SERVICE BULLETIN

M-1236

Safety Recall Code 0136

2009 Dyna Fuel Tank Vent Tube Assembly Recall

Figure 1. Vent Tube Connections

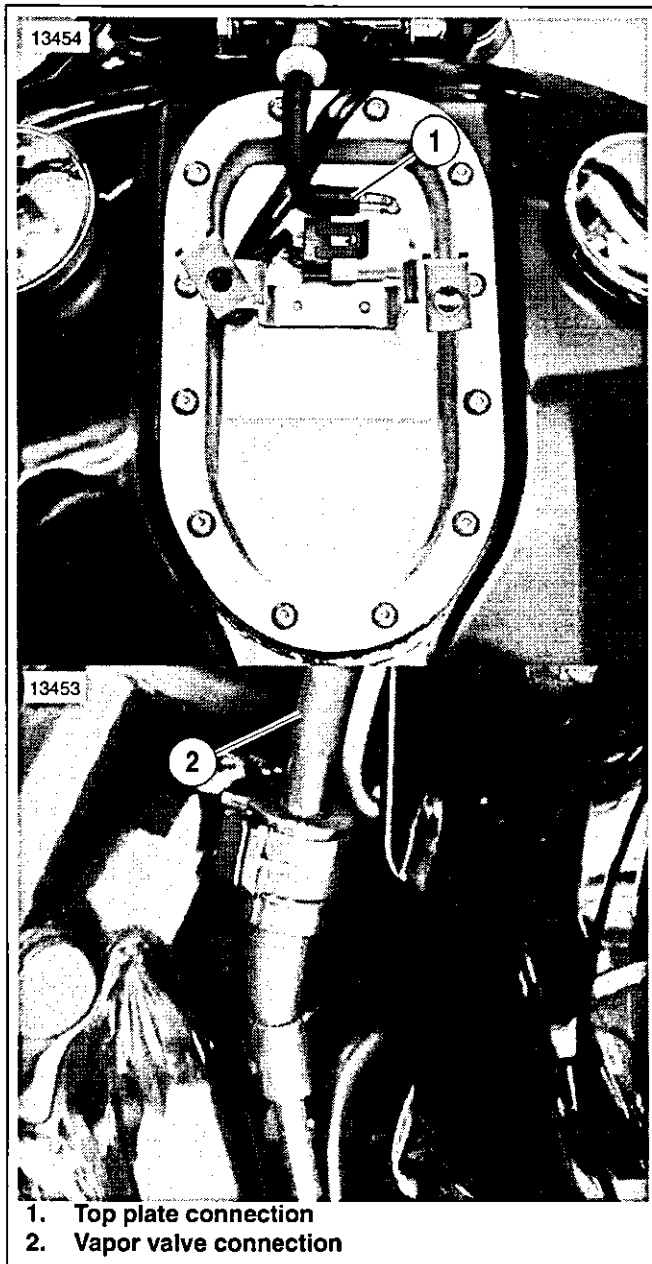
See Figure 1. Do not remove vent tube at slosh valve. Remove vent tube at top plate (1) and vapor valve (2).

4. Remove the anti-slosh valve and attached vent tubes.
5. See Figure 2. Install new anti-slosh valve and vent tubes from the recall kit.
6. Install instrument panel. See Chapter 7 of the 2009 DYNA Models Service Manual.

Figure 2. Anti-slosh Valve

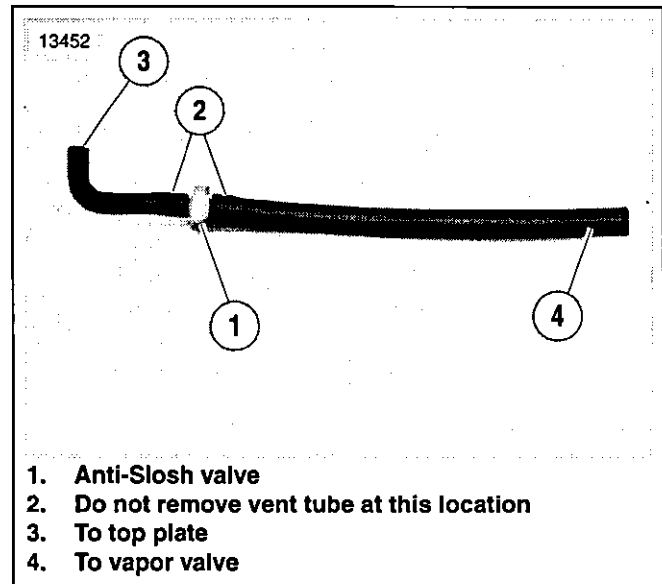
Harley-Davidson has determined that a condition affecting motor vehicle safety exists on certain 2009 model year FXDB, FXDC, FXDF, FXDL vehicles. These motorcycles have a fuel tank vent tube assembly (Part No. 27389-04A) which may have been produced at the supplier with a questionable ultrasonic weld on the anti-slosh valve. If the valve separates and the bike is tipped over, it may leak fuel. This condition could lead to a fire, which could cause injury or death to the rider.
